PILATUS AIRCRAFT LTD. STANS, SWITZERLAND

**SERVICE BULLETIN**

PC-9

# AIRCRAFT STRUCTURE - GENERAL DO A CHECK OF THE MATERIAL SPECIFICATION USED DURING MANUFACTURE AND, IF NECESSARY, DO A CHECK FOR CRACKS OR REPLACE THE PART

Front and Rear Rudder-Pedal Outboard-Bearings (P/N 553.20.09.062 / 231) - Inspection (If Necessary) Figure 25, Sheet 1 of 2

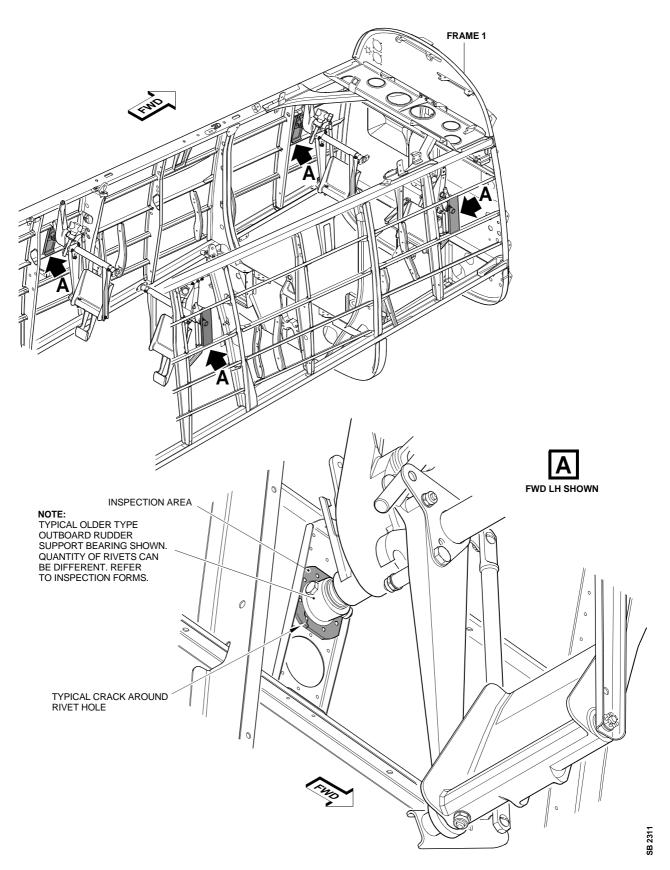
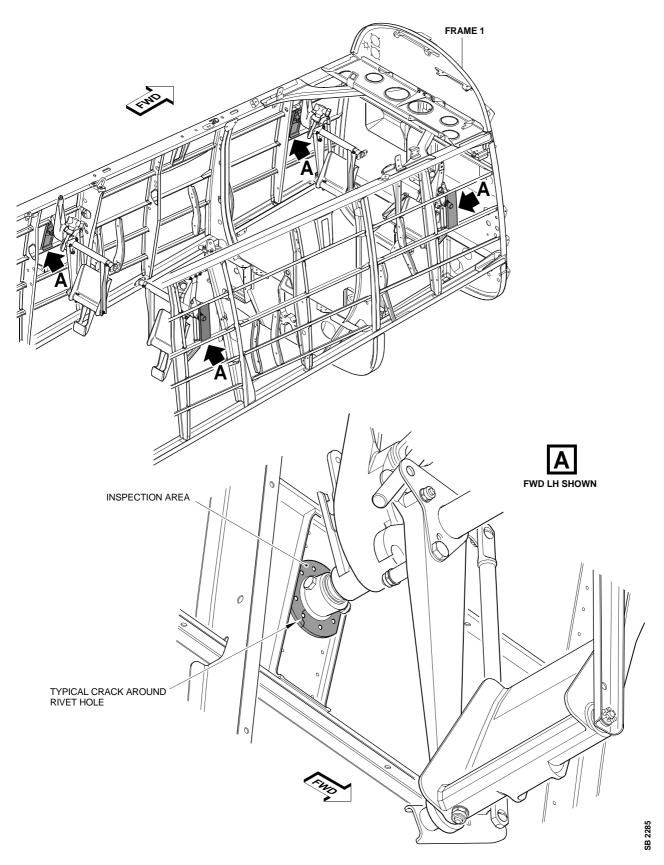
- (a) Do a check to identify which outboard bearings are installed:
  - If the outboard bearings looks the same as the one shown in sheet 1 of Fig. 25, it's part number is 553.20.09.062 or 553.20.09.231 and it is made from AA2024-T351, continue the Service Bulletin from Step 3.B.(13)(e).
  - If the outboard bearings looks the same as the one shown in sheet 2 of Fig. 25, it's P/N 553.20.09.235 and can be made from AA2024-T351 or AA2124-T851, continue the Service Bulletin from Step 3.B.(13)(b).
- (b) Do the conductivity test to find the material of the outboard bearing (P/N 553.20.09.235) and the support plates (P/N 553.20.09.229).

- <u>1</u> If necessary, remove the insulation material from the outboard bearings (P/N 553.20.09.062, P/N 553.20.09.231 or P/N 553.20.09.235) (Ref. SRM, 53-10-00, Page Block 201).
- Use the absorbent paper (Material No. P02-031) made moist with the solvent (Material No. P01-010) and remove the dirt and grease from the inspection areas of the outboard bearings (P/N 553.20.09.062, P/N 553.20.09.231 or P/N 553.20.09.235).

Front and Rear Rudder-Pedal Outboard-Bearing-Support Plates (P/N 553.20.09.229) - Inspection Figure 27

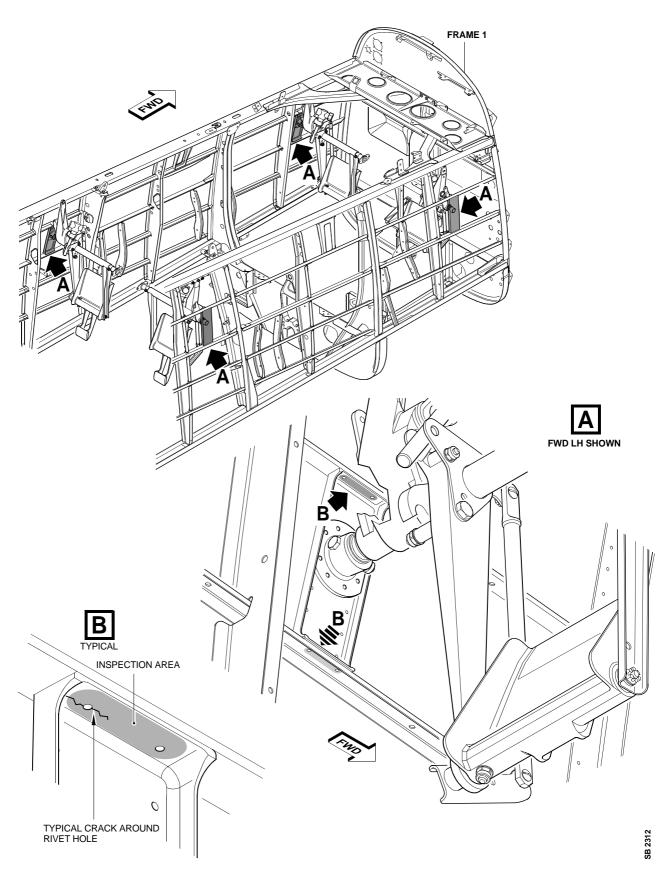
- 1 If necessary, remove the insulation material (Ref. SRM, 53-10-00, Page Block 201) from the support plates (P/N 553.20.09.229).
- Use the absorbent paper (Material No. P02-031) made moist with the solvent (Material No. P01-010) and remove the dirt and grease from the inspection areas of the support plates (P/N 553.20.09.229).
